Field No. PA-1254 Office No. H-8116

Locality Spieden Channel

REVIEW OF HYDROGRAPHIC SURVEY

REGISTRY NO. H-8116

AD. WK. H-8116 (1958)
Scale 1:10,000

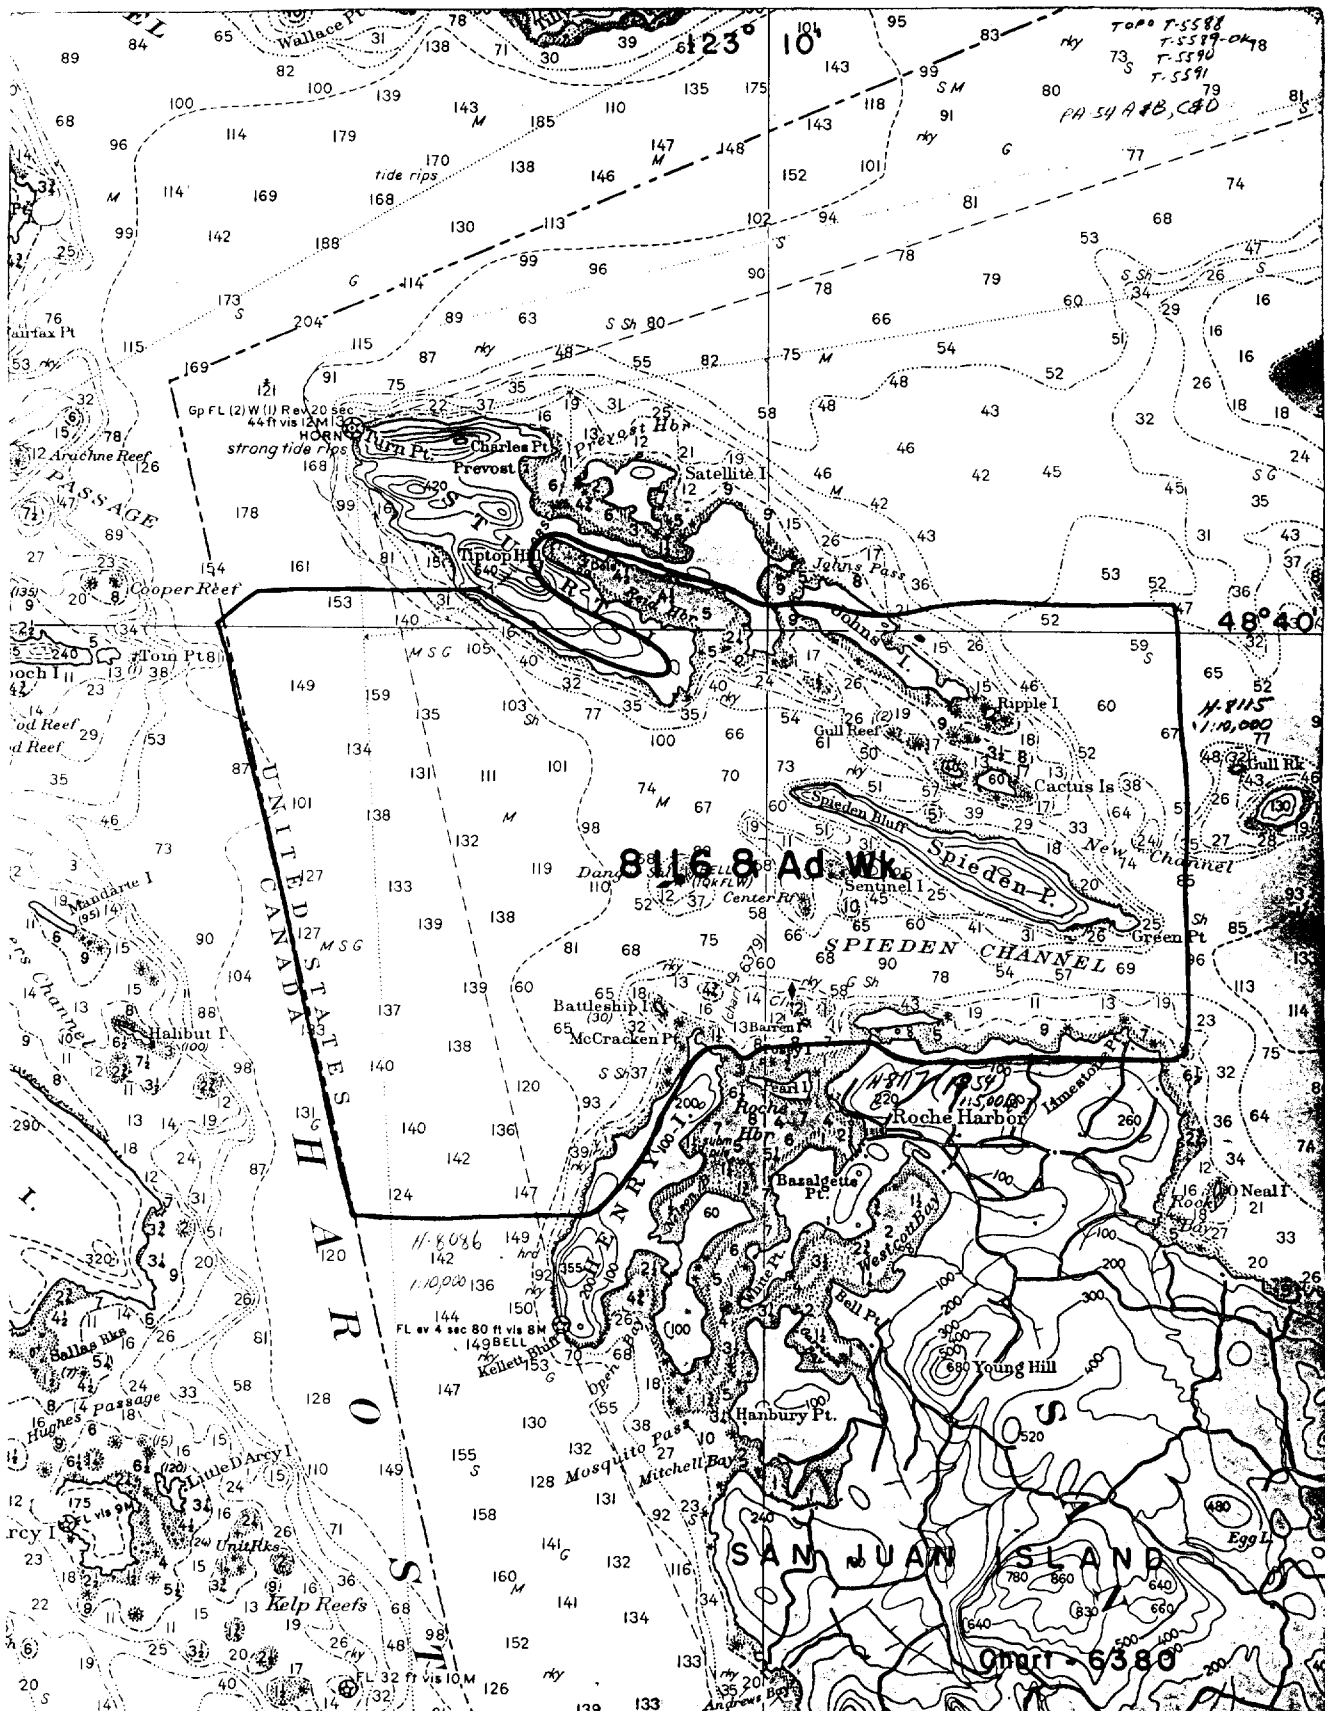
→ 0⁶ fath sdyg transfered in in red violet from H-2214(1894)
Disproved.

2 fath sdyg from Ad. Wk H-8116(1958) shown on H-8116(1954)
in Brown.

0⁶ removed from sheet; sdyg from Add. Wk. shown in brown.

4. The existence of the 1/2-fm. sounding at this location is considered adequately disproved. The sounding should be deleted from the charts.
5. This 1958 work has not been charted.
